**JEA Brandy Branch
Combined Cycle Conversion**

**JEA-Brandy Branch
Sufficiency Response**

Re: JEA-Brandy Branch Conversion Project
Site Certification Application
FDEP File No. PA 00-43
DOAH Case No. 00-5120EPP
OGC Case No. 00-2321
Response to Statement of Sufficiency

Exhibit 8F

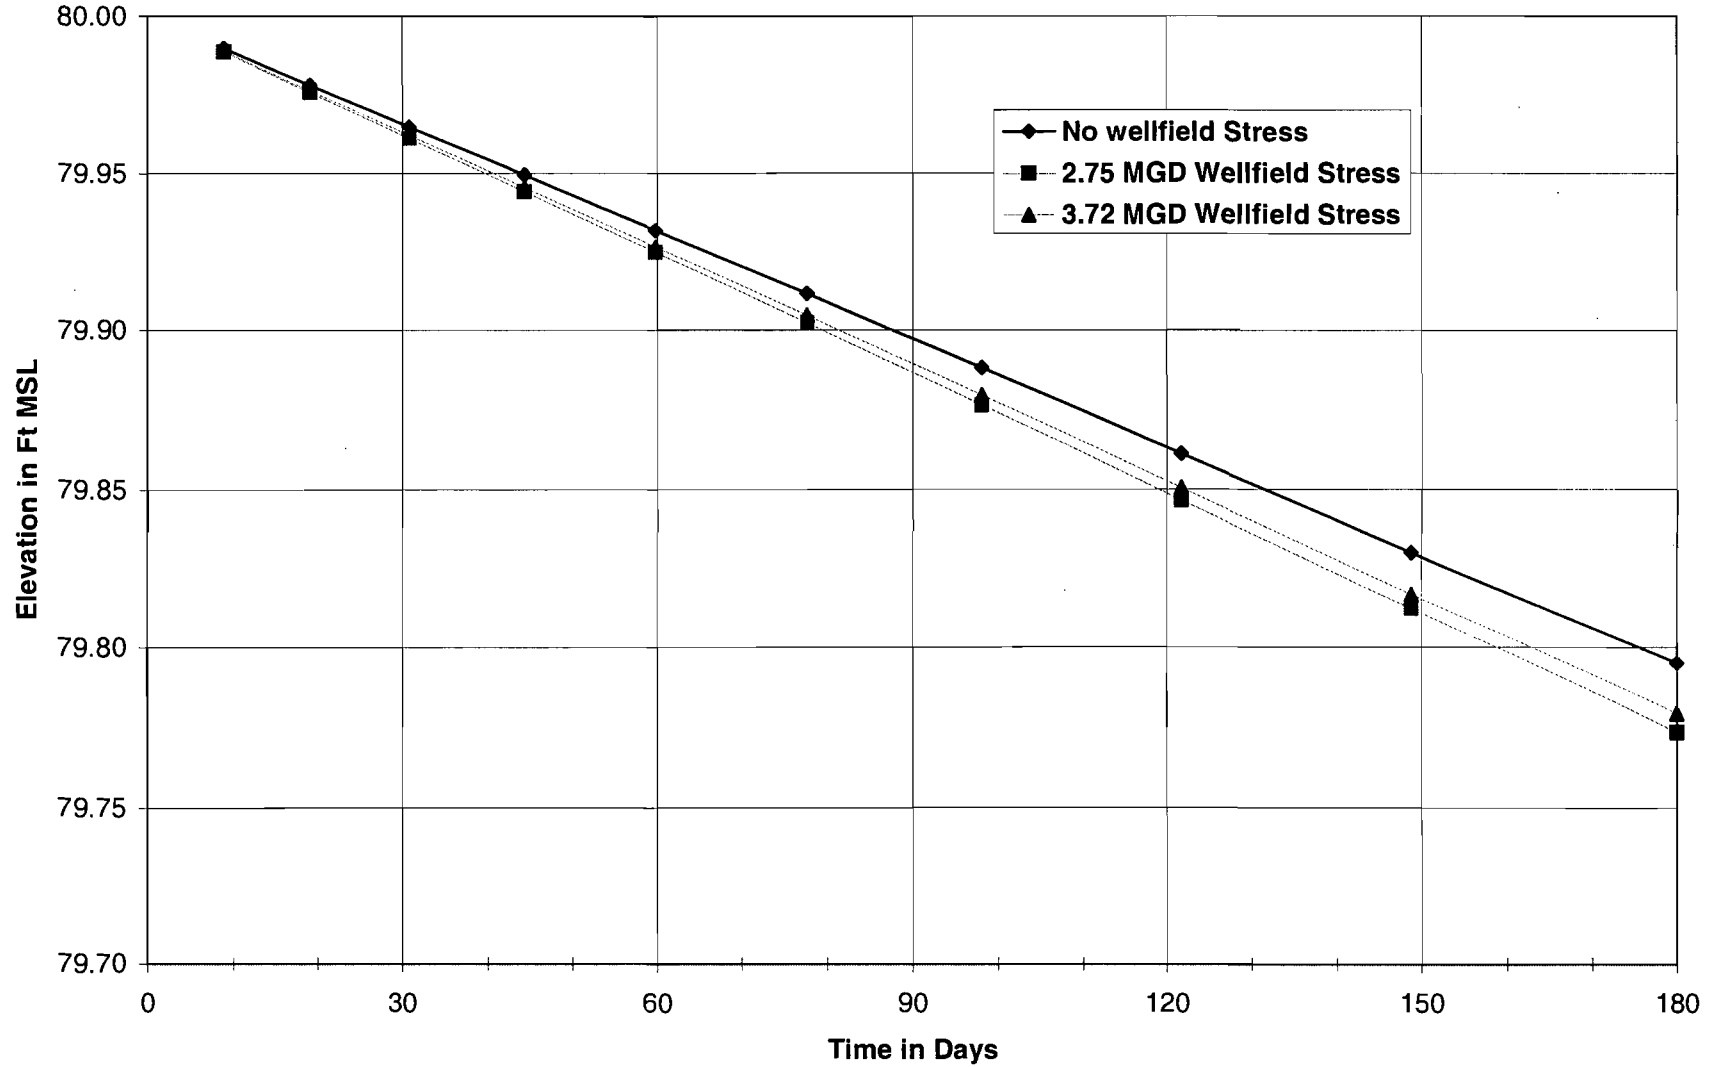
1. *The application indicates that there are herbaceous and forested wetlands as well as other surface waters on and surrounding the proposed site. The ground water modeling, however, analyzes the drawdown impacts to the Floridan aquifer only. Please provide an analysis of the steady-state impact of the proposed Floridan aquifer withdrawals on the surficial water table at the maximum proposed pump rate of 2.744 million gallons per day (mgd) and at increased rate of 3.722 mgd for 288 hours, transient conditions. The drawdown contours should be overlain on a map of wetlands and surface waters and displayed at one-half foot intervals and also delineate outward from the well(s) to the 0.2 foot drawdown contour. [Section 10.2(e)(f)(g)(l)(p), 10.3(d), Applicant's Handbook Consumptive Uses of Water (February 8, 1999) (A.H.)]*

Exhibits 8-A through 8-H show time series graphs for a 180 day period at the center of the wellfield, and at distances of 1,000 ft, 2,000 ft, 3,000ft, 4,000 ft, 5,000 ft, 7,500 ft, and 10,000 ft from the center of the wellfield. The baseline scenario with no wellfield pumping is identical regardless of the distance from the wellfield. This baseline drop in water table elevation amounts to 0.21 feet over the 180 day period or 5.1 inches per year, comparing well with the simple calculation of the previous paragraph. At the center of the wellfield the 2.75 MGD scenario added an additional 0.04 ft (0.48-inch) to the baseline scenario after 180 days and the 3.72 MGD added an additional 0.05 ft (0.60-inch) to the baseline scenario after 180 days. Using a 90 day period, the two pumping scenarios added an additional 0.02 ft (0.24 -in) and 0.025-ft
